SERVICE BULLETINNO. 5DATE 3.12.87CFM METAL-FAX LTD CONSIDERSCOMPLIANCE - ~~Mandatory~~/Recommended/~~Optional~~
(delete which is not applicable)

<u>SUBJECT</u>	AILERON CONTROL ROD ENDS
<u>MODELS AFFECTED</u>	All Models - CFM SHADOW
<u>SERIES NOS. AFFECTED</u>	B and B-D
<u>COMPLIANCE TIME</u>	As soon as possible
<u>PURPOSE</u>	To reduce wear on the threaded Rod Ends - RM 3U - (part no. CM42), which connect the aileron push/pull tube (part no. W153) to the aileron control horn on the control surface, and the threaden inserts (part no. W189) which are held by rivets into the aileron push/pull tube.
<u>INSTRUCTIONS</u>	Remove the rod end, RM 3U, ((1) each control surface) and apply LOCTITE 242e or equivalent to the rod end and re-install.
<u>MATERIAL REQUIRED</u>	LOCTITE 242e or equivalent.
<u>AVAILABILITY OF PARTS</u>	Not applicable.
<u>EFFECTIVITY DATE</u>	
<u>SUMMARY</u>	The wear on the Rod End is caused by the Rod End rotating in the insert with aileron movement.
<u>NOTES</u>	Make sure that the Rod End is re-installed in the aileron push/pull tube in the same position as before it was removed.

Service Bulletin #14

- 1 **Title:**
Cracking of Tailplane Spar Leading Edge Spigot Tub

SERVICE BULLETIN N° 7

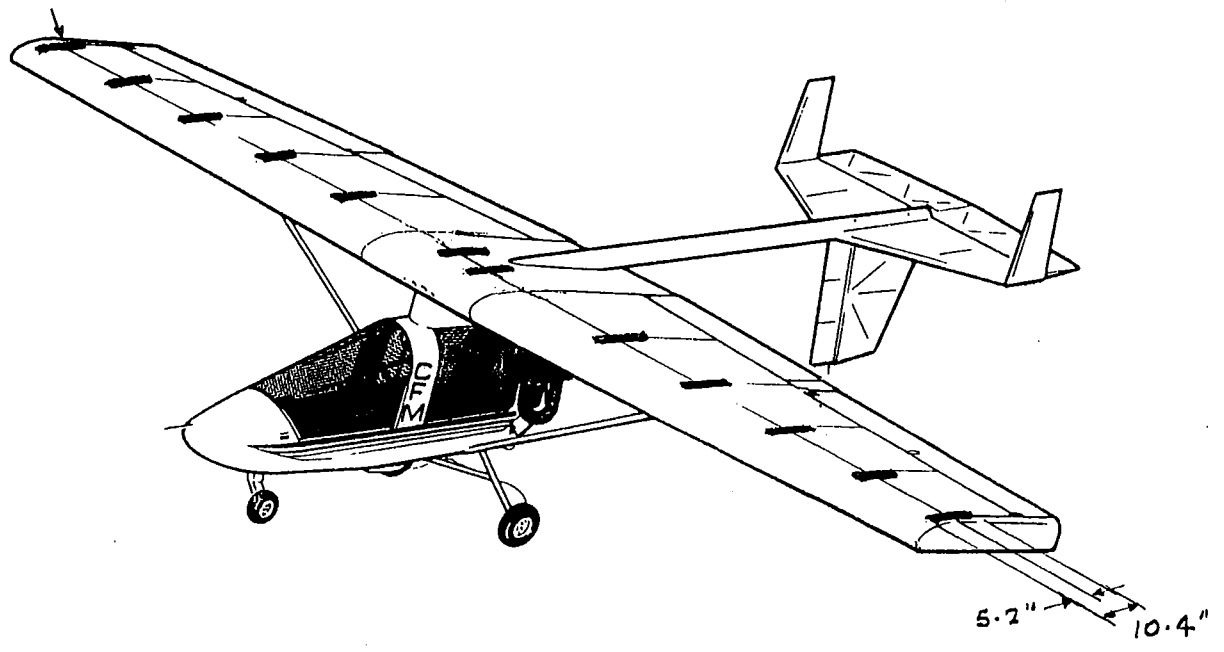
<u>SUBJECT</u>	SOLAR HEATING OF UPPER WING SURFACES COLOURED OTHER THAN WHITE
<u>MODELS AFFECTED</u>	SHADOW SERIES B, B-D, C, C-D, STREAK SHADOW SERIES S-A1, S-A
<u>SERIAL NOS. AFFECTED</u>	ALL SERIAL NUMBERS
<u>COMPLIANCE TIME</u>	IMMEDIATE
<u>PURPOSE</u>	TO ELIMINATE POSSIBLE STRENGTH DEGRADATION DUE TO HEAT BUILD-UP WHILST AIRCRAFT IS EXPOSED TO SOLAR RADIATION.
<u>INSTRUCTIONS</u>	ON UPPER WING SURFACES ONLY, AT 'D' BOX TO TRAILING RIB JUNCTURE, APPLY WHITE PAINT /REFLECTIVE STRIPS (10.4" LONG) EQUALLY SPACED, FORE AND AFT TO 'D' BOX SKIN AND THE TOP OF THE TRAILING RIB. ENSURE SURFACE IS FREE FROM DUST, DIRT OR GREASE BEFORE APPLYING STRIPS.
<u>MATERIAL REQUIRED</u>	ALUMINIUM FOIL REFLECTIVE TAPE, REF. 6930, 50mm x 3.2m (MANUFACTURED BY 3M) OR WHITE PAINT
<u>AVAILABILITY OF PARTS</u>	CFM OR LOCALLY OBTAINED.
<u>EFFECTIVITY DATE</u>	11.6.90
<u>SUMMARY</u>	
<u>NOTES</u>	THIS IS A PRECAUTIONARY MEASURE AGREED WITH THE C.A.A. WHILST CFM CONDUCT TESTS UNDER SPECIFIC CONDITIONS. NO SERVICE HISTORY OF FAILURE OR SOFTENING OF THE COMPOSITES HAS BEEN EXPERIENCED TO DATE. COMPLIANCE WITH THIS SERVICE BULLETIN SHOULD BE RECORDED AND CERTIFIED IN THE AIRCRAFT LOG BOOK.

2" STRIP REFLECTIVE ALUMINIUM TAPE
(12) PLACES

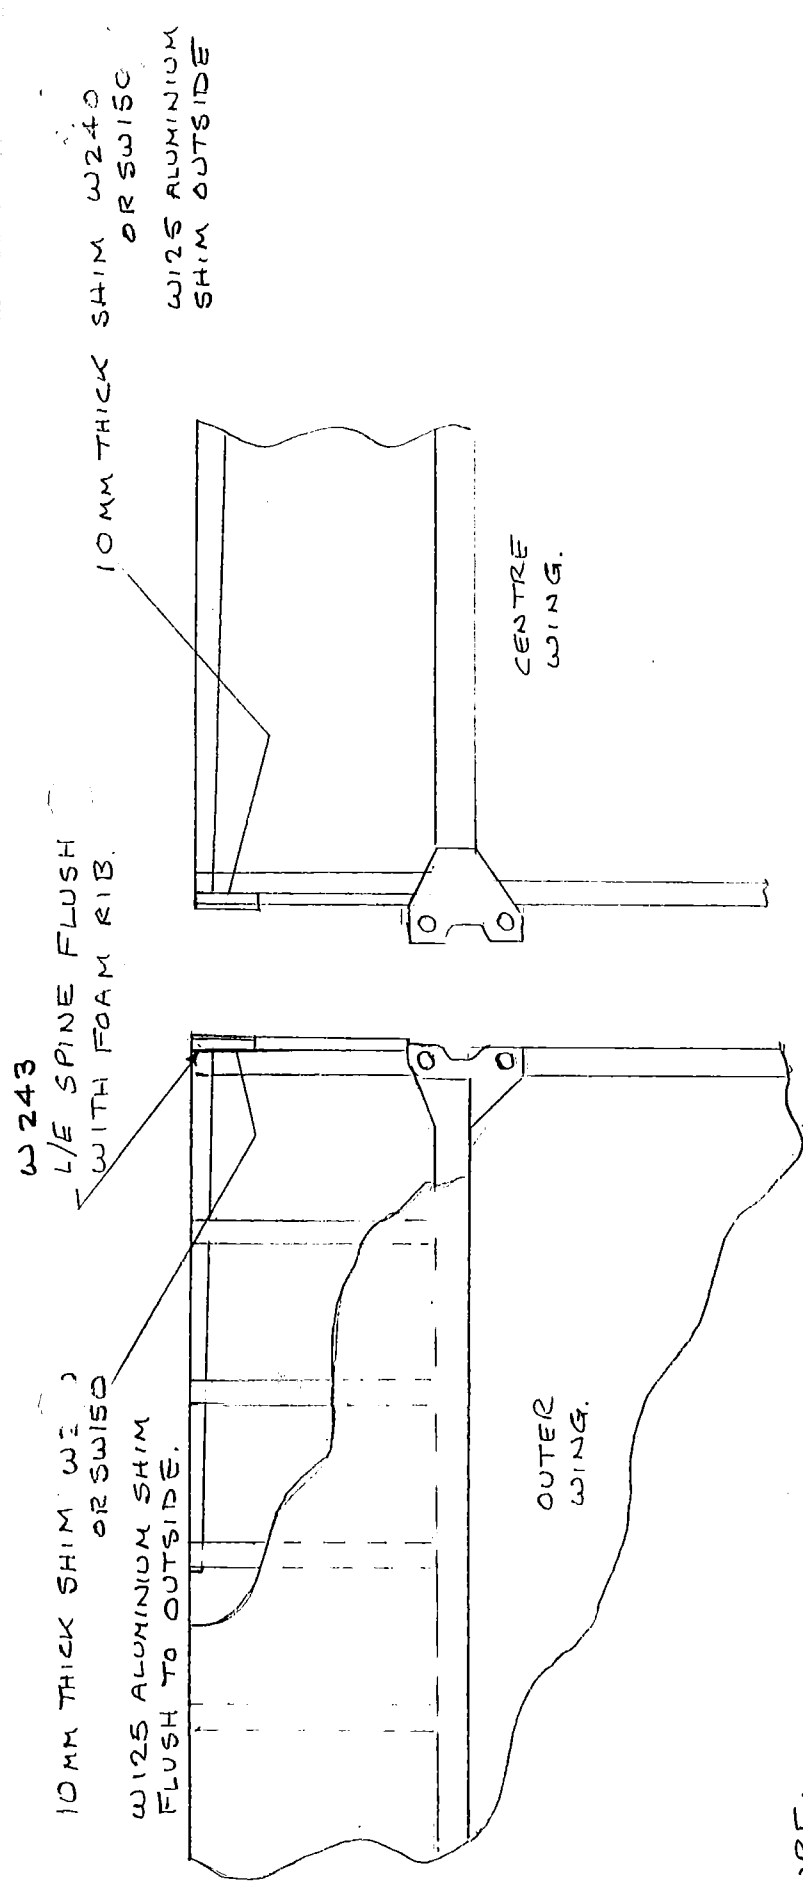
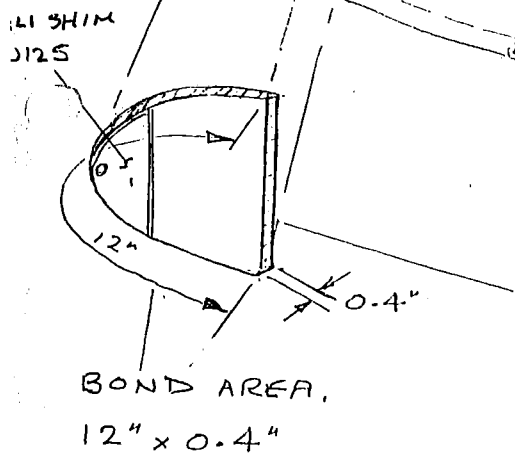
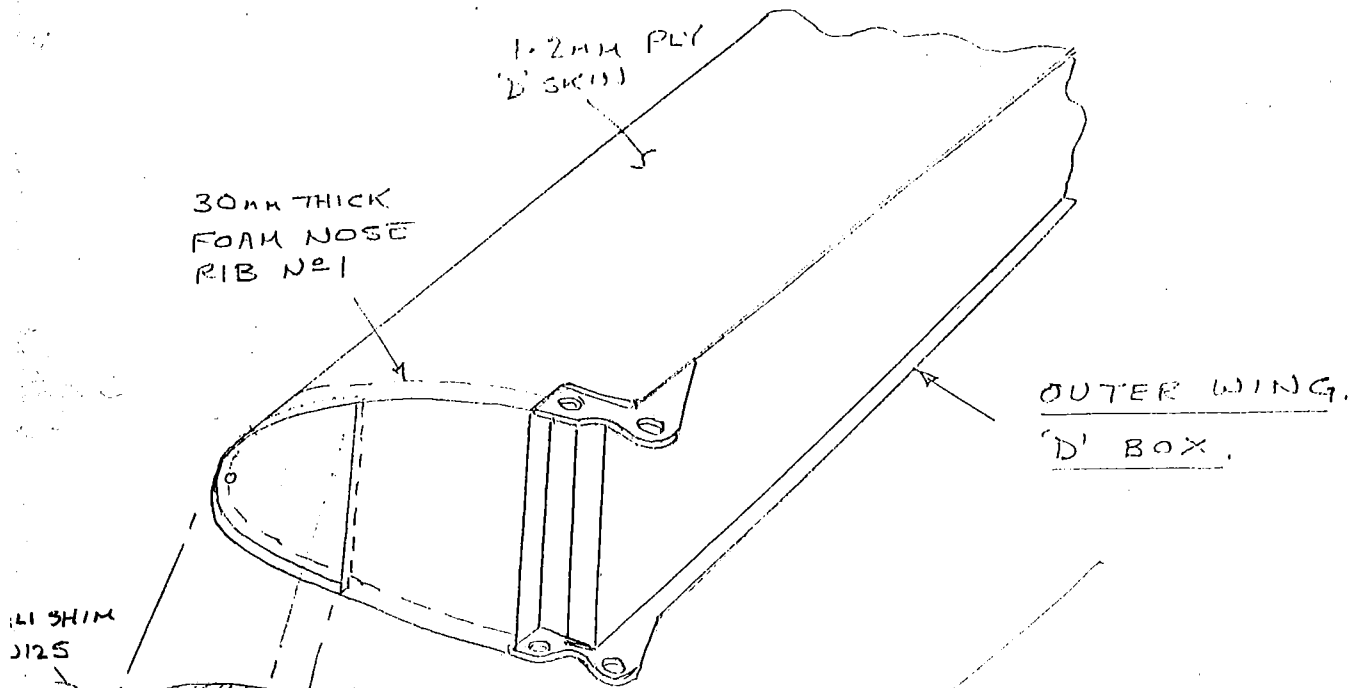
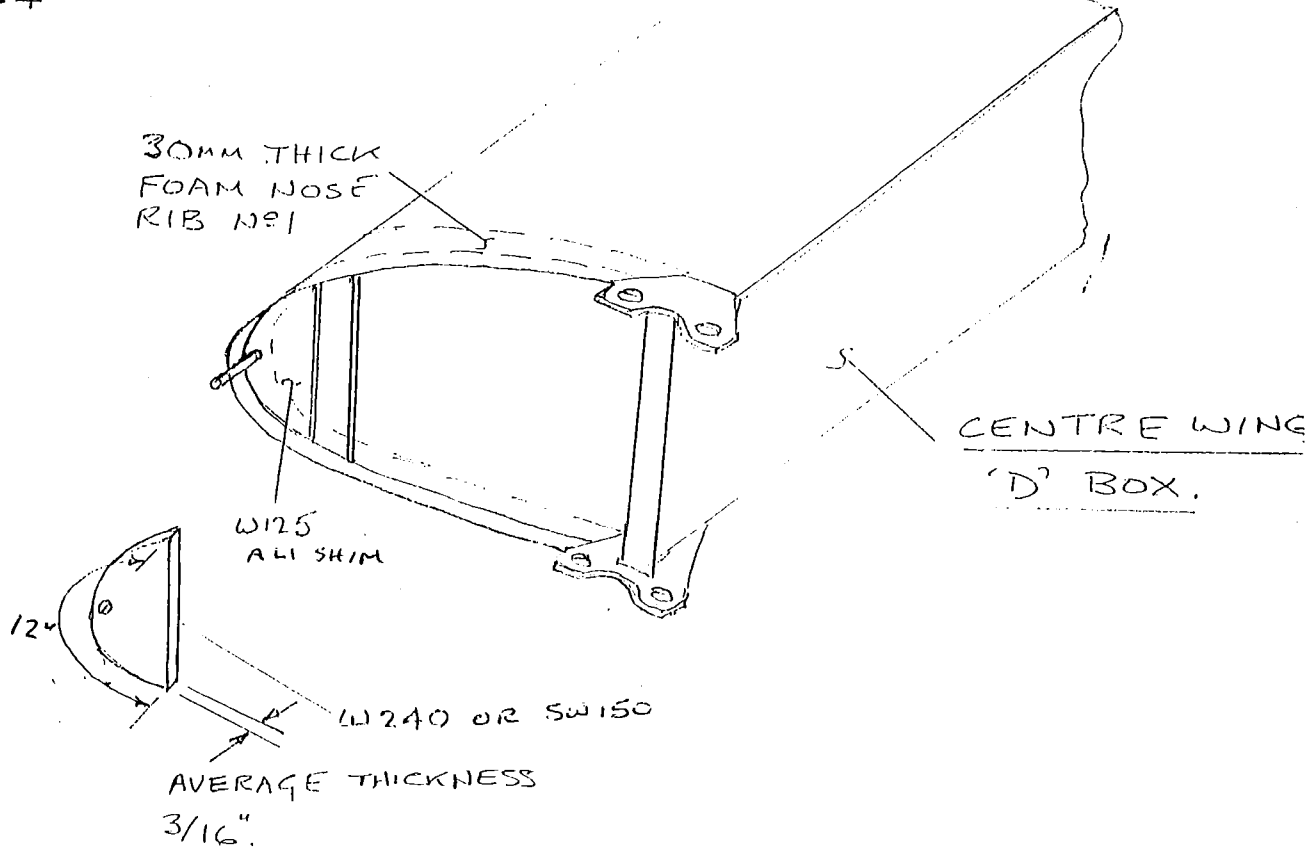
<u>SUBJECT</u>	FORE/AFT WING MOVEMENT
<u>MODELS AFFECTED</u>	B/B-D, C/C-D, S-A/S-AI, SA-M, SS.
<u>SERIES NOS. AFFECTED</u>	ALL SERIAL Nos. EXCEPT D/D-D
<u>COMPLIANCE TIME</u>	NEXT RENEWAL OF PERMIT
<u>PURPOSE</u>	TO PROVIDE FOR ANTI DRAG FORCES AT INNER/OUTER WING JUNCTURE - D BOX NOSE SECTION.
<u>INSTRUCTIONS</u>	ADD WING NOSE SPAR TO OUTER WINGS. ADD PLY PRESSURE PAD TO CENTRE WING AND OUTER WINGS. SEE SEPARATE INSTRUCTIONS.
<u>MATERIAL REQUIRED</u>	(2) L/E SPINE W243 (4) PAD W240 SHADOW } DEPENDANT ON MODEL (4) PAD W150 STREAK } QUICK SET ARALDITE #2012 300g PACK
<u>AVAILABILITY OF PARTS</u>	CFM METAL-FAX LTD.
<u>EFFECTIVITY DATE</u>	SEPTEMBER 1996
<u>SUMMARY</u>	THIS BULLETIN CAN BE PERFORMED BY:- 1) CFM METAL-FAX LTD. 2) THE SHADOW FLIGHT CENTRE LTD.
<u>NOTES</u>	THE CORRECT GAP BETWEEN CENTRE/OUTER WINGS AT NOSE OF 'D' BOX IS 1 TO 1.5 mm WHEN AIRCRAFT IS RIGGED AND WINGS IN FORWARD PRESSURE (NOSE WHEEL ON TOUCHING GROUND).

REMOVE W125 OFF NOSE FOAM RIB - OUTER AND CENTRE WINGS.
 ON OUTER WINGS CUT A SQUARE HOLE JUST SMALLER THAN CROSS SECTION OF W243 AT NOSE L/E.
 PUSH W243 INTO CUTOUT BETWEEN L/E PLY SKIN AND FOAM RIB WITH W243 ABRASIVE SIDE TO FOAM.
 WORK INWARDS UNTIL 10-12MM PROTRUDES. WITHDRAW, REMOVE ABRASIVE.
 APPLY ABRASIVE TO PLY L/E SIDE AND PUSH UNTIL END IS FLUSH WITH FOAM RIB.

SHIM 10MM THICK IS REDUCED IN THICKNESS WHICH WHEN W125 IS ADDED THE TOTAL THICKNESS IS FLUSH WITH L/E PLY EDGE.

SHIM 10MM THICK IS REDUCED - IF NECESSARY TO BE FLUSH WITH L/E PLY EDGE.
 W125 IS ADDED BY ITS THICKNESS PROUD OF EDGE. (THIS SETS WING GAP)

FIN
ASSEMBLY

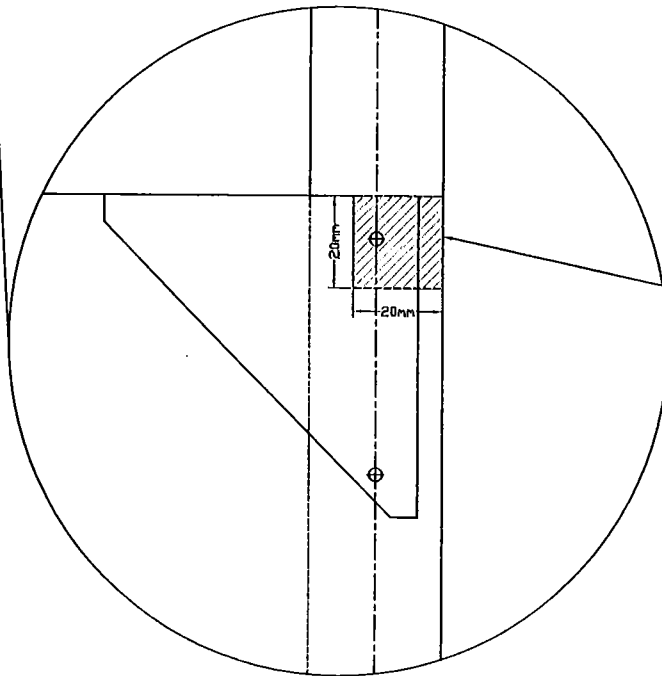
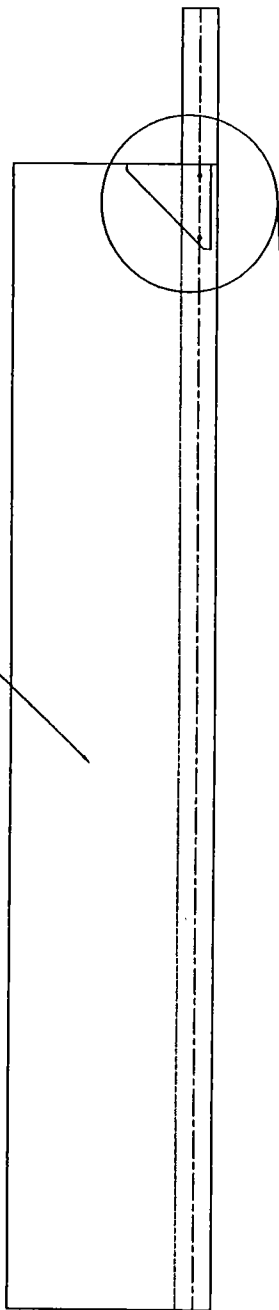
SUBJECT	Rudder Fin Post			
MODELS AFFECTED	B, C & D Series Shadow, Streak Shadow & Star Streak			
SERIAL Nos AFFECTED	All			
COMPLIANCE TIME	Before further flight			
PURPOSE	To identify possible cracks in the top of the rudder fin post in the vicinity of the top of the rudder fin where the fin post enters the boom tube. Rectify where necessary.			
ACTION	<p>Remove the rudder fin post from the aircraft. Remove a small section of the covering material (20mm x 20mm) on both sides of the fin around the gusset and the fin post itself at the root (see attached drawing). Inspect for cracks. It is not necessary to replace the covering material after inspection provided that the all remaining fabric is fully glued to the surface of the gusset.</p> <p>In the event that a crack is present, the entire rudder fin post (Part T 147) must be replaced prior to further flight with a new Rudder Fin Post Assembly (Part T189)</p> <p>In the event that no crack is present, a strengthening sleeve (Part T 188) must be installed in the top of the fin post, prior to the aircraft's next annual inspection (Modification 40)</p> <p>Record the inspection and replacement/modification in the aircraft logbook</p>

COVERING TO BE
REMOVED FOR
INSPECTION

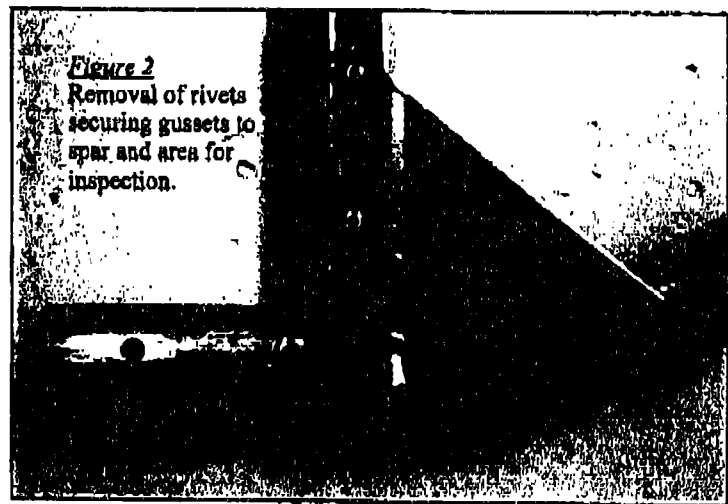
Accomplish inspection / rectification action detailed in paragraph A before further flight and accomplish inspection / rectification action detailed in paragraph B of Accomplishment Instructions within 50 hours or before the next permit renewal, whichever the sooner.
- 6 **Accomplishment Instructions:**
 - A. Remove the tailplanes from the aircraft. Using a Stanley knife, carefully remove a triangle of fabric covering the upper & lower gussets at the corner of each tailplane, where the leading edge joins the root rib. See figure 1. Care should be taken to avoid scratching the surface of the aluminium spars.

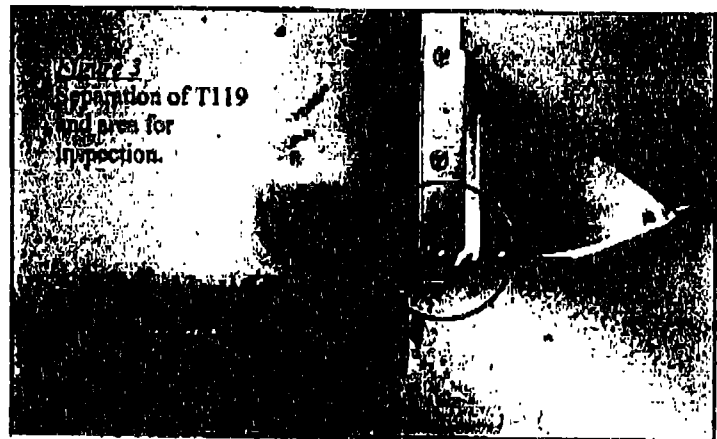
Using a new 1/8" drill, remove the heads of the rivets, which attach the gussets to the leading edge of the tailplanes. Take care not to oversize the holes in the tubes. See Figure 2.

The area for inspection is indicated by the circle in figures 2 & 3.

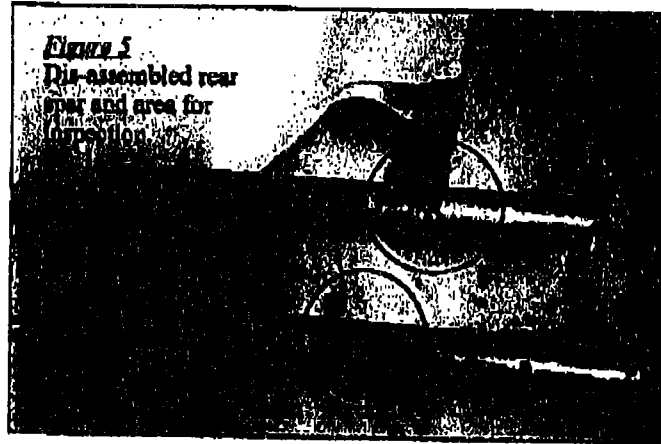
- B. Remove tailplanes from the aircraft, and remove gussets/root rib at the leading edge as detailed in paragraph A above. In addition remove a further triangle of covering at the trailing edge as shown in *Figure 4*. Remove all rivets attaching the gussets to the rear spar tube. Remove all additional rivets holding the reinforcing tube to the rear spar. Do not remove the rivets attaching the gussets to the root rib.

Separate the assembly and fully inspect for cracks at or near the rivet holes that attach the root rib to the rear spar. See *Figure 5*. A recognised dye penetrant crack detection method must be used.
